Product Change Notification

Product Name: RD-03A-RS/RD-03A-B-RS

This notice is to inform you of changes to the RD-03A-RS series.

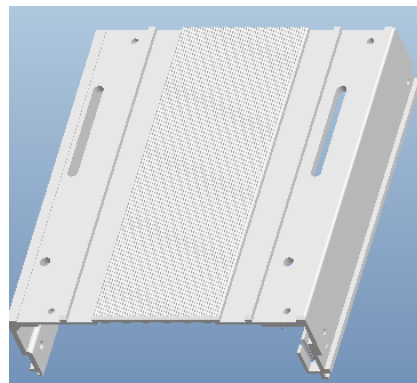
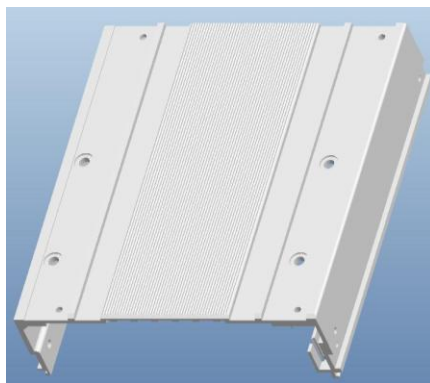
1. In order to increase the compatibility of 6TB 3.5" HDD installation, we modify the bottom cover by adding two ellipse holes also change the middle screw holes to ellipse.
2. In order to increase the compatibility of SAS and SATA SSD/HDD installation, we modify SATA connector by remove the bulkhead between power 15pin and data 7pin.

Change design from

to
